## **OYLER COURT SUBDIVISION**

The plat illustrates the proposed 29 Lot / 20.0± Acres subdivision, which is located on the East side of Oyler Road, 1,000'± South of Jeff Hamilton Road and extending North to the West terminus of Crary Avenue, and is outside the city limits, but within the Planning Jurisdiction. The subdivision is served by public water and sanitary facilities.

The purpose of this application is to create 29 lots from a metes and bounds parcel.

# DETAIL SITE PLAN

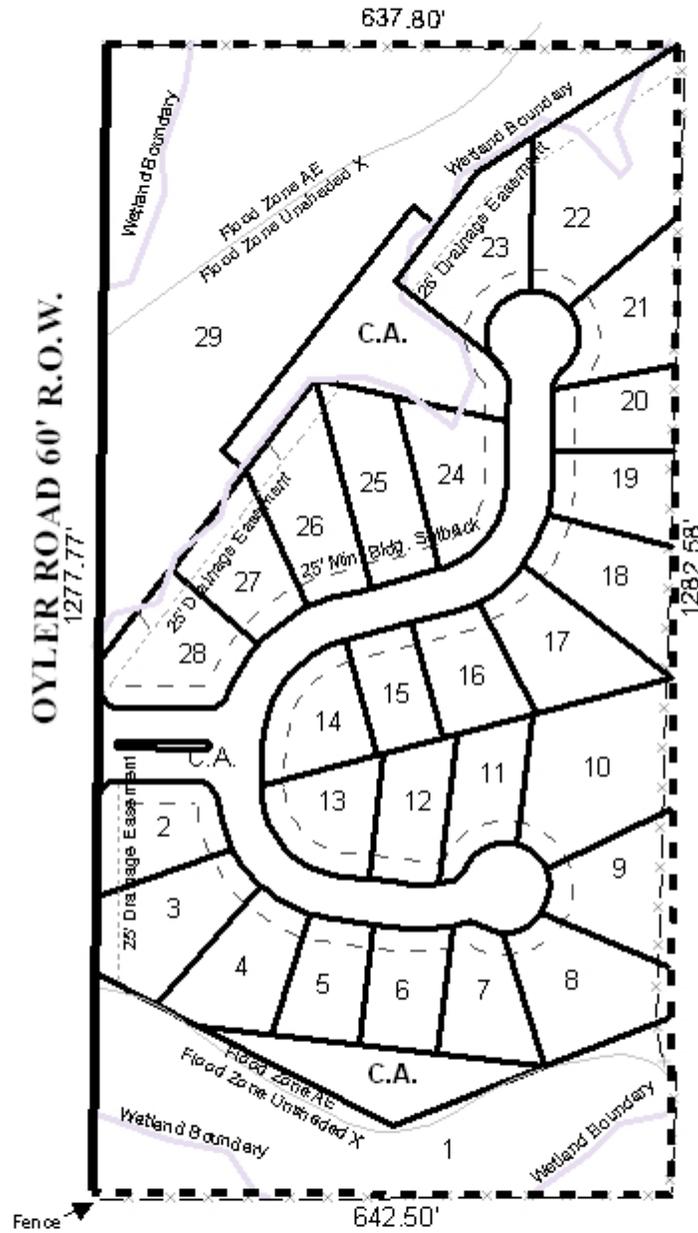
The new road for the site is to be dedicated and constructed to meet County Engineering Standards. Additionally, since Lots 2 and 28 have frontage on three streets, a note should be placed on the Final Plat stating that Lots 2 and 28 are limited to one curb-cut each with the size, design and located to be approved by County Engineering.

The areas of open space are labeled as common area, wetlands, islands or median in the roadway, as well as detention areas. All areas not designated as lots should be labeled as common areas, and a note should be required on the Final Plat, if approved, stating that maintenance of all common areas is the responsibility of the property owners (association).

While the site is in the County, the applicant's engineer will be required to certify that the stormwater detention, drainage facilities, and release rate comply with the City of Mobile stormwater and flood control ordinances, prior to the signing and recording of the final plat, if approved. The plat should also be revised to depict lot sizes to be illustrated in square feet either through labeling or the provision of a table on the Final Plat.

The Subdivision Regulations require 15,000 square feet for lots that are served by public water and individual septic systems or 30,000 square feet for lots that are served by individual wells and septic systems; therefore, the need for field lines on each lot is what necessitates the larger lot size. If the development proposes a centralized system, none of the lots will have field lines, thereby eliminating the necessity for the increased size. However, it appears that several lots do not meet the minimum size requirements for developments with access to public water and sanitary sewer as required in Section V.D.2. of the Subdivision Regulations and MAWSS comments that no water or sewer services are available.

Additionally, the applicant should revise the preliminary plat to provide the size of each lot in square feet on the plat, either as a table or as a label for each individual lot on the Final Plat and submit a letter stating that.

1. the new roads within the proposed subdivision be dedicated and constructed to County Engineering standards;
2. the placement of a note on the Final Plat stating that Lots 2 & 28, are limited to one curb cut, with the size, design and location to be determined by County Engineering;

3. all areas not designated as lots should be labeled as common areas (including wetlands and detention areas), and a note placed on the final plat stating that maintenance of all common areas is the responsibility of the property owners (association);

4. placement of a note on the Final Plat stating that any lots which are developed commercially (or multi-family residential) and adjoin residentially developed property must provide a buffer, in compliance with Section V.A.7. of the Subdivision Regulations;

5. provision of a certification letter from a licensed engineer to the Planning Section of Urban Development, certifying that the stormwater detention, drainage facilities, and release rate comply with the City of Mobile stormwater and flood control ordinances, prior to the signing and recording of the final plat;

6. labeling of all lots with size in square feet, or placement of a table on the plat containing the lot size information; and
7. the submission of a letter stating the compliance of Section V.D.2. of the Subdivision Regulations prior to the signing of the Final Plat or documentation from the developer stating the location and design of a centralized sanitary system to handle the wastewater of the subdivision.
